Product Change Notification

Change Notification #: 113064 - 00
Change Title: Intel® Server System R1208BB4DC
PCN 113064-00, Product Design
Update System PSU Bracket
Date of Publication: June 13, 2014

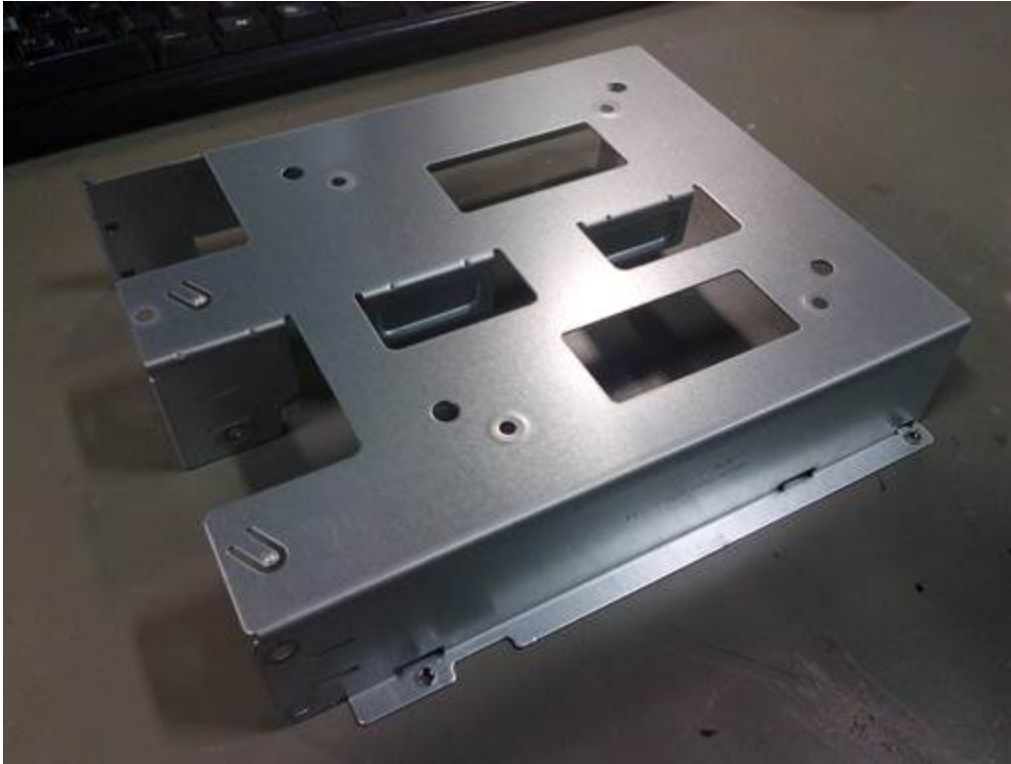
- Update the Power Supply bracket by removing the middle punch. Please refer to the following pictures for details:

Pre-change:

Post-change:
